Technical Service Bulletin: tsb101169

Released Date: 03-Jul-2002

New Aftercooler Coolant Tubes

Figure 1, New Arrangement (Right Bank)

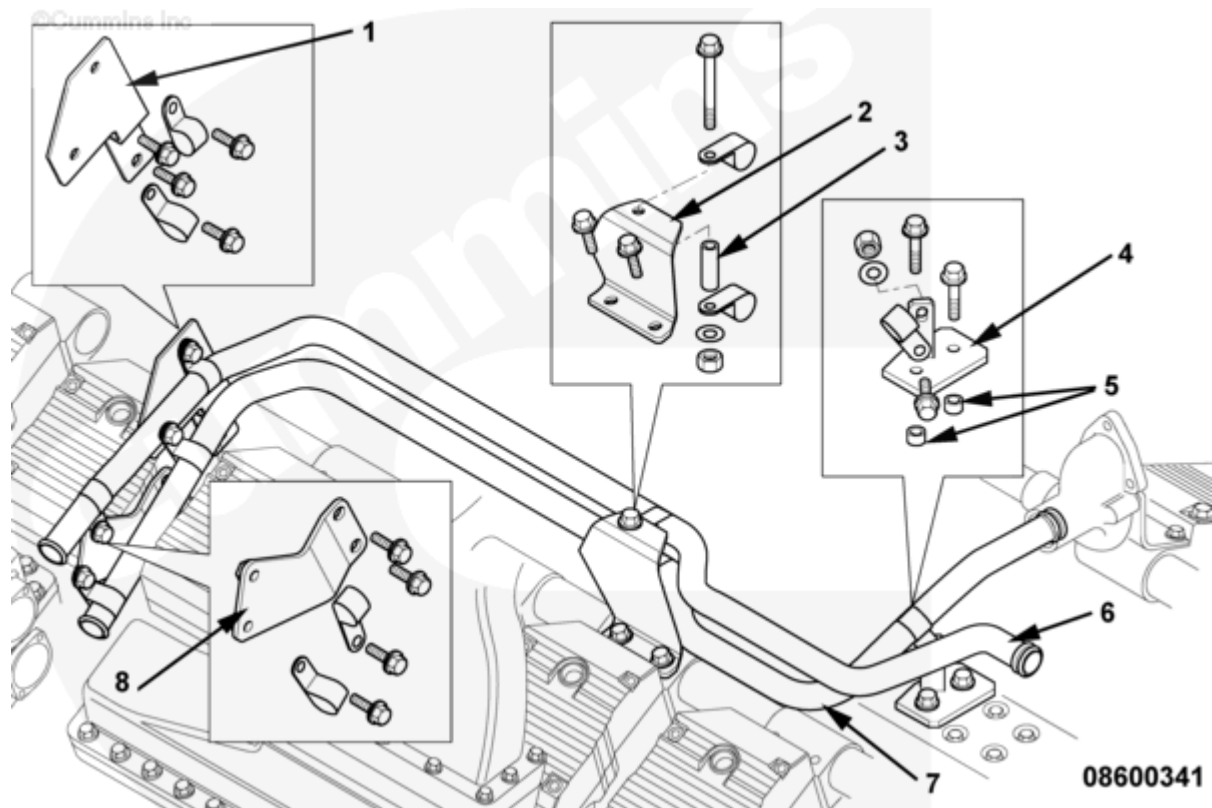
This service/parts topic announces the introduction of new one-piece aftercooler coolant tubes on all QSK60 series engines in order to address failures due to coolant tube seal wear.

This change replaces the existing eight-tube arrangement with a new four-tube arrangement.

The two mid-point connection blocks and associated brackets are eliminated. Pipe securing brackets are also introduced.

Table 1, Parts Changes - Right Bank (Refer to Figure 1):

New One-piece Design		
Item Number	Part Number	Description
Fig. 1, Item 1	4066204	Bracket, water tube
Fig. 1, Item 2	4080251	Bracket, water tube
Fig. 1, Item 3	4080242	Spacer, mounting
Fig. 1, Item 4	4080248	Bracket, water tube
Fig. 1, Item 5	4080241	Spacer, mounting
Fig. 1, Item 6	4017624	Tube, water transfer
Fig. 1, Item 7	4017625	Tube, water transfer
Fig. 1, Item 8	4080243	Bracket, water tube
